ADDENDUM

ADDENDUM NO.: 02
PROJECT NAME: Kenwood Academy Link and Mechanical (Rebid)
PROJECT NO.: 05326
CONTRACT NO.: C1602R
DATE OF ISSUE: February 29, 2024

NOTICE OF CHANGES, MODIFICATIONS, OR CLARIFICATIONS TO CONTRACT DOCUMENTS

1 EAST PENTHOUSE PLAN - KENWOOD (BUILDING C) 1/4" = 1'-0"

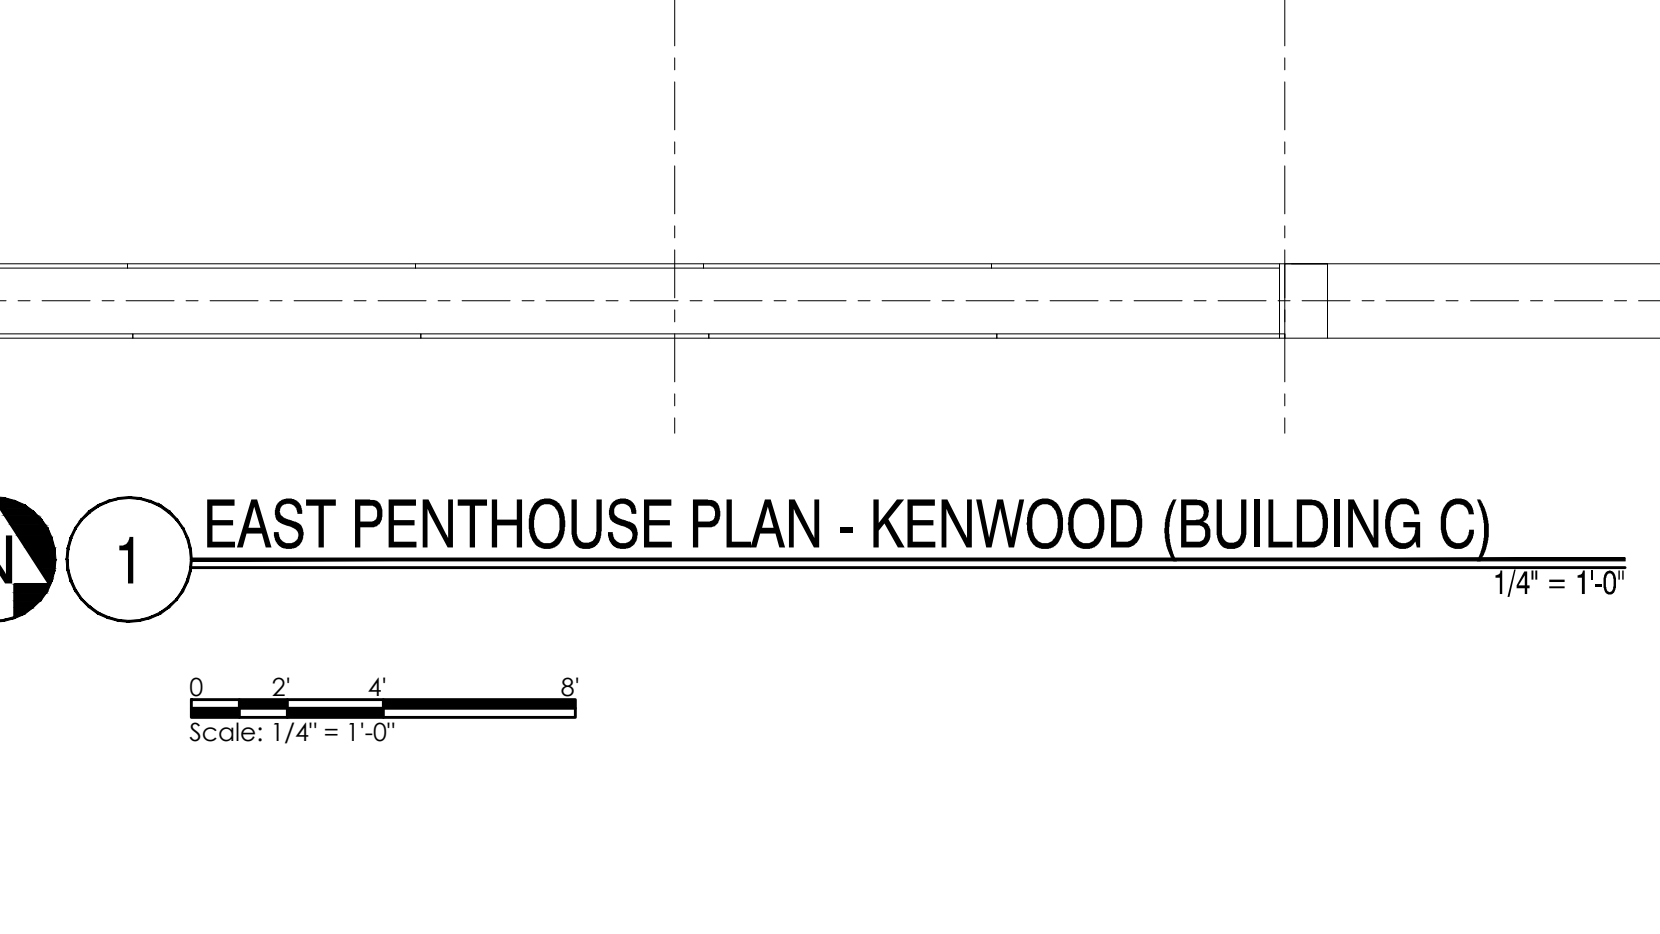
- Change 14** **REVISED** Drawing M103-MEP MECHANICAL PENTHOUSE PLANS: KENWOOD (BUILDING C) Updated DX pipe sizing
- Change 15** **REVISED** Drawing M104-MEP MECHANICAL ROOF PLANS - KENWOOD (BUILDING C): Updated DX pipe sizing & condensing unit weights
